REVIEW OF DETERMINATION ASSESSMENT REPORT

Application Number:	REV2020/0023
----------------------------	--------------

Responsible Officer:	Anne-Marie Young
Land to be developed (Address):	Lot 4 DP 18667, 205 Riverview Road AVALON BEACH NSW 2107
Proposed Development:	Review of Determination of Application DA2019/1069 for alterations and additions to a dwelling house including a swimming pool
Zoning:	E4 Environmental Living
Development Permissible:	Yes
Existing Use Rights:	No
Consent Authority:	Northern Beaches Council
Delegation Level:	DDP
Land and Environment Court Action:	Yes
Owner:	Kristen Rooney
Applicant:	Kristen Rooney

Figure 1 : Building height non-compliance with 8.5m shown in pink

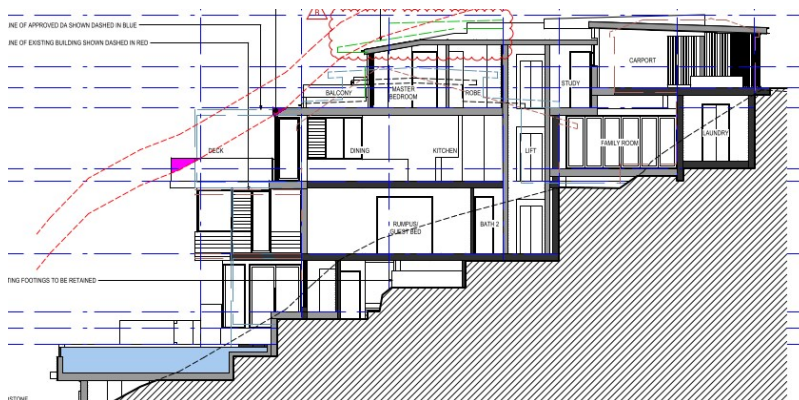
The building height non-compliance with the 8.5m height is demonstrated in the images below.

While the proposal includes an additional floor, the non-complying elements relate to the amendments to the existing three levels that are proposed to be reconfigured with internal changes, new access and balcony elements and a new roof form. The changes recommended by the Panel do not result in a change to the building height which has been assessed as acceptable.

Figure 2 : Building height non-compliance with 8.5m shown in pink. (Note: the deck to the master-bed room is no longer non-compliant)

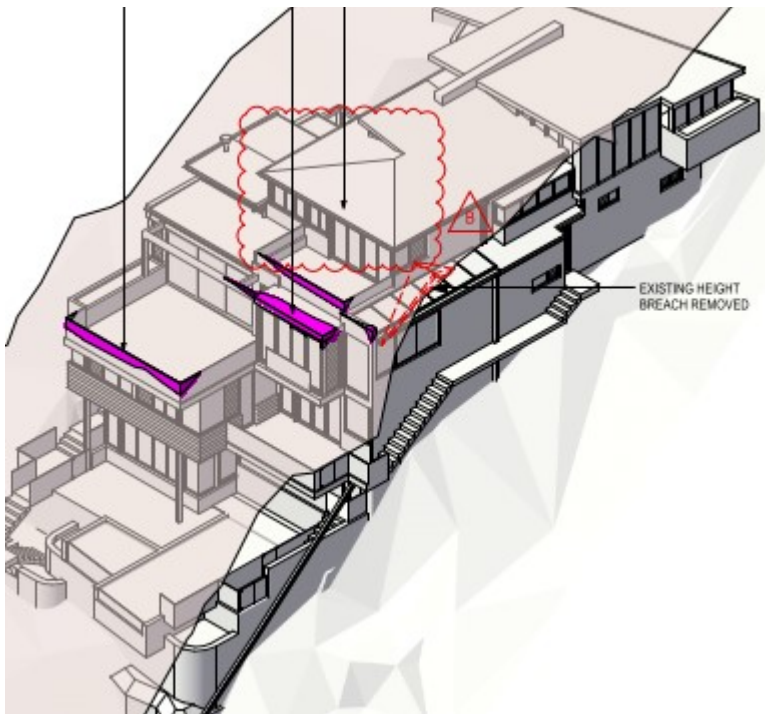
The portions of the development that exceed the 8.5m building height plane are limited in height and depth, as demonstrated in the figures above. The protrusions are described as being minor.

Figure 3. Extent of excavation shown red

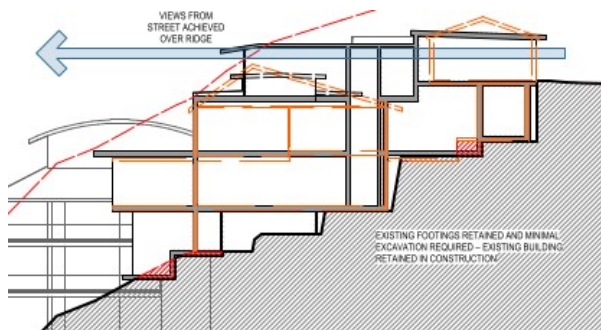
The proposal is reliant upon a minor volume of excavation under the footprint of the carport on the Ground Floor Level and under the footprint of the Lower Ground Floor Level for the proposed toilet and bathroom for the Pool Level as shown in figure 3. However, the visual impact of the minor excavation will be screened from view, and the proposal presents as a dwelling that has been sited to sympathetically follow the natural slope of the land.

East elevation of the original (refused) proposal under DA2019/1069

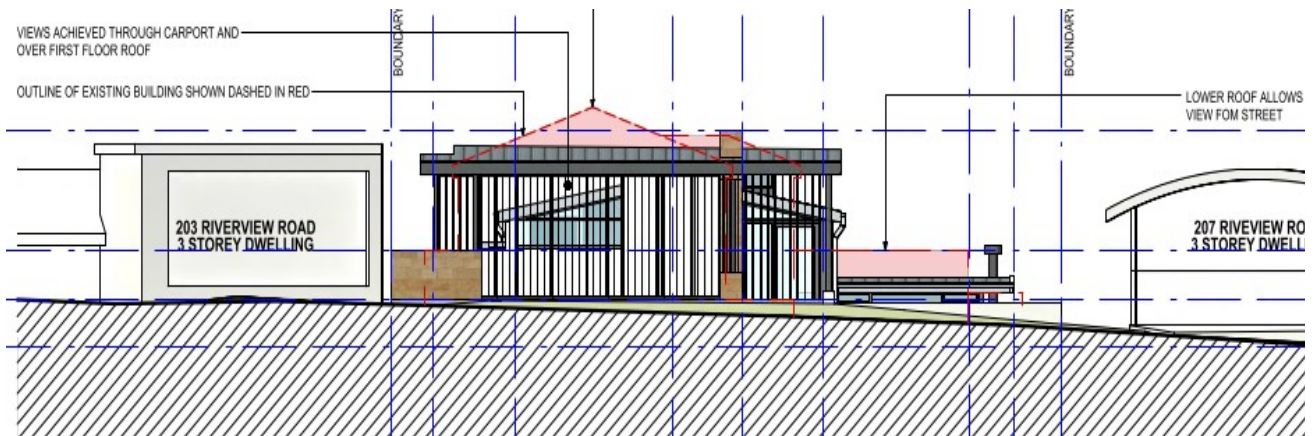
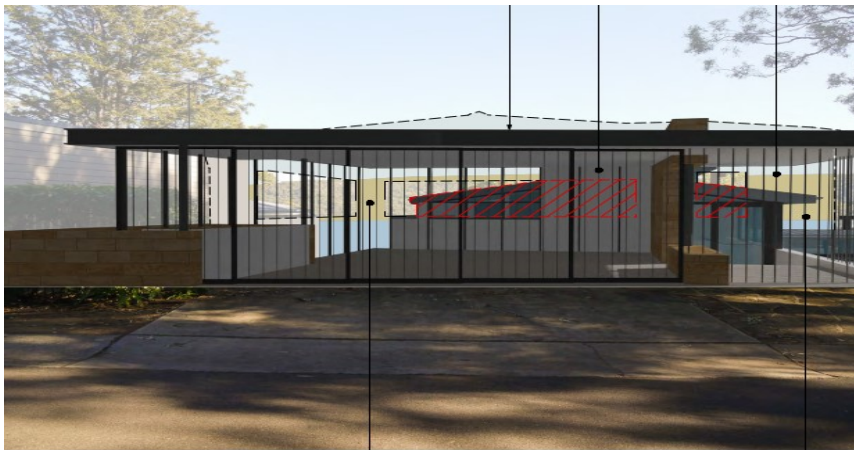
The revised proposal addresses the Panels concerns with a transparent screen to the front and either side of the carport to minimise the visual impact of the structure when viewed from Riverview Road and allow improved partial views to the Pittwater Waterway from the public street. The design of the carport reduces the built form of the existing car port. The pitched tiled roof profile is reduced with a lower height flat roof profile and the brick walls, balustrades and piers are replaced with lightweight steel posts which have been spaced to allow improved views to the Waterway from the public domain, refer to images below.

East elevation of proposed carport showing refined transparent screen and lower boundary wall to street

Existing sunlight to deck 9.00am (outlined in red)

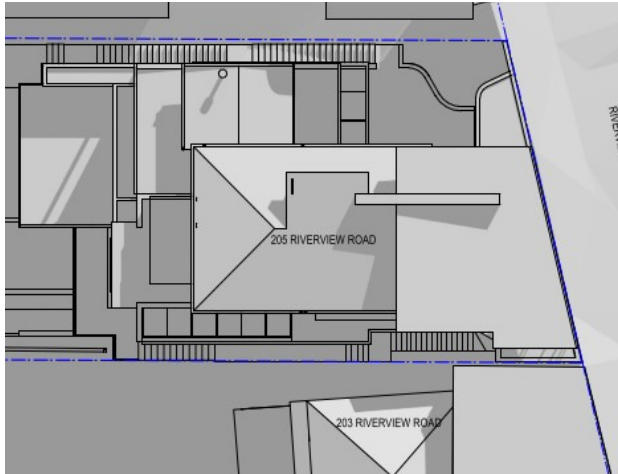
**Proposed 9.00am shadow, the deck is in shadow.
(Note: there is no change to the shadow impact in
the DDP recommended scheme)**

The main private open space affected by the development is the west facing deck located on the middle level of No. 203 Riverview Road. The existing building overshadows the northern elevation of the deck which currently has a privacy screen attached to its northern edge. However, it should be noted that this deck receives full sunlight between 12.00 noon and 3.00pm, complying with the control, refer to the plan shadow diagrams above.

**Proposed sunlight to deck at 12.00 noon
(Neutral impact to existing development)**

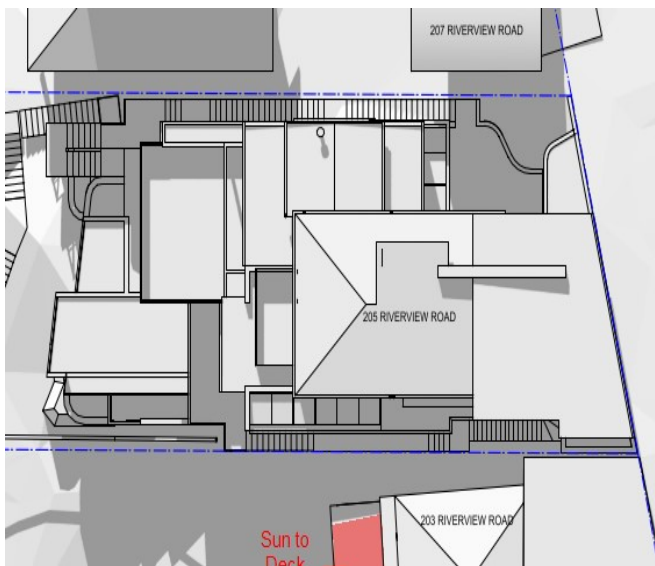
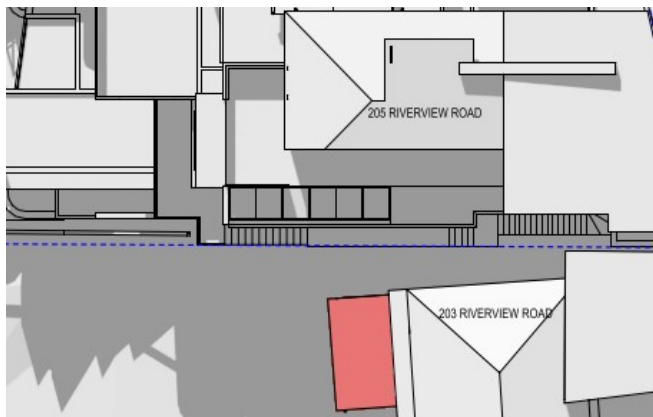
**Proposed sunlight to deck with DDP scheme at 12 noon
(Slight improvement to the existing situation and the proposed
scheme, namely a 5.4sqm (10.7%) increase in proposed and existing solar access)**

The changes requested by the DDP will result in a small (5.4sqm or 10.7%) increase in sunlight to the northern elevation of the deck at 12.00 noon and 1.00pm only. It is noted that the proposal, without the requested setback, will have a neutral impact to the existing solar access to the deck.

Level 1 plan - New section of stair highlighted in blue

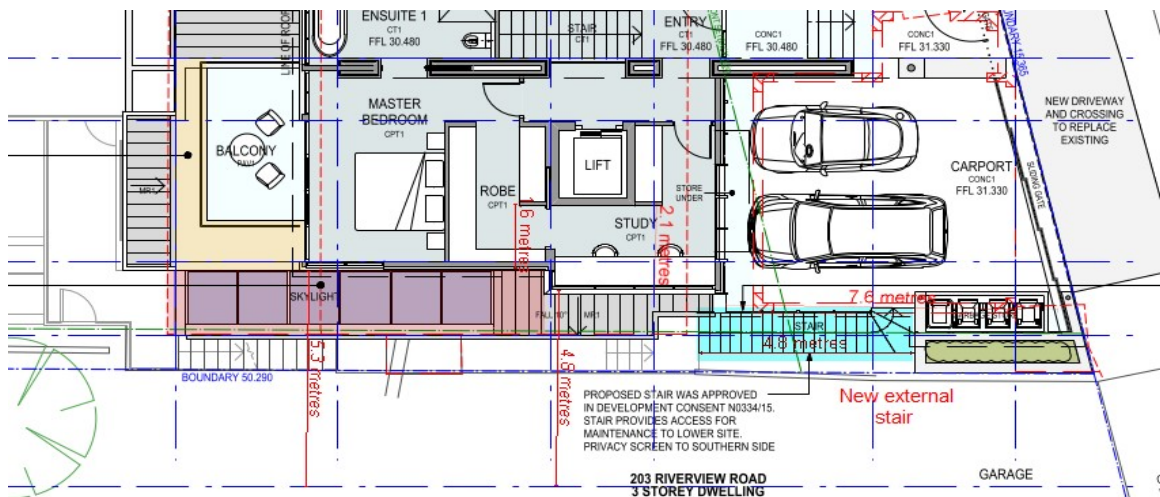
The proposal has been amended to include a 1.6m high privacy screen to the new section of external stair will ensure that privacy is maintained to the bedroom window in the northern elevation of No. 203 Riverview Road. In addition, it is noted that the section of new stair provides a secondary transitional connection between carport at ground level and the existing service stair which provides access to lower external levels of the subject site. The principle pedestrian access is located on the northern side of the dwelling. As such, it is not anticipated that the use of this stair will give rise to excessive use or visual or acoustic amenity impacts to the southern neighbour.

The privacy impacts to the new section of stair have been assessed as **neutral impact** given the existing arrangement, the addition of the privacy screen and the fact that this is a secondary service stair. A site visit has also confirmed that the southern boundary has extensive vegetation which provides a soft screen between the stair and the neighbouring property. In addition, the existing service stair has a 1.6m privacy screen attached to the southern edge. The applicant in justifying the stair notes that the structure was approved under N0334/15. A search of Council records confirm that this is correct.

East elevation showing the area requested to be deleted (highlighted in red)

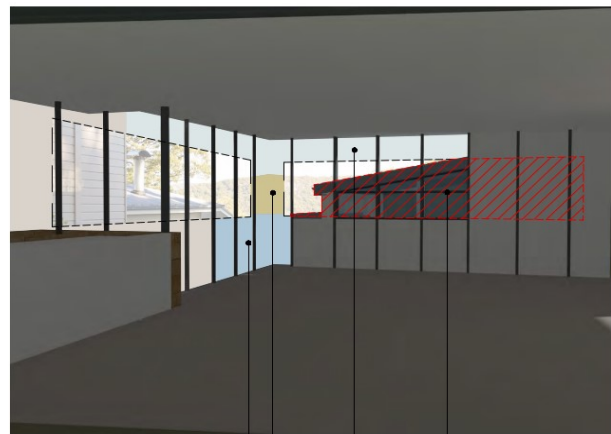
The area which the panel requested to be deleted presents limited opportunities for view sharing from the public street as the view is obscured by existing trees. Furthermore, the proposal has the benefit of removing the existing southern gable roof which will enhance the view corridor to the southern side of the dwelling. This combined with open design of the car port allows for any potential view loss of the upper floor to be off set with some view gain.

On balance, the design, the bulk and scale of the fourth floor addition will have limited visual impact on the streetscape being located behind the carport and affecting limited views obscured by mature trees. The screens to the carport have been re-designed to be more open and transparent and the proposal, as amended, has been assessed as being consistent with the desired future character of Avalon and the visual impact of the proposal on Riverview Road will be negligible. Proposed and existing landscaping, in conjunction with conditions relating to colours and materials conditions contained within this report, will assist to visually screen the bulk and scale of the built form and integrate the built form into the landscape. Refer to images below:

Comparison of existing masonry car port and proposed carport (the brick pillars and balustrades will be replaced with a lightweight frame which has the potential to opens up views to the south-west corner) - view loss area is referenced as the area hatched red

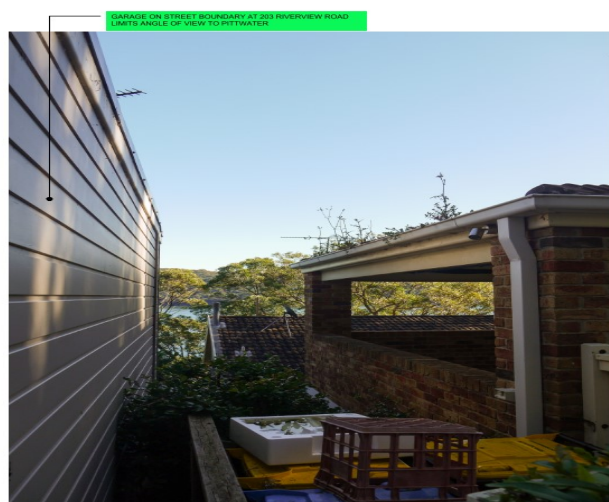
VIEW LOSS IS OFFSET BY VIEW GAIN

HEAVY BRICK PILLARS AND BALUSTRADES REMOVED TO OPEN VIEWS TO PITTPATER
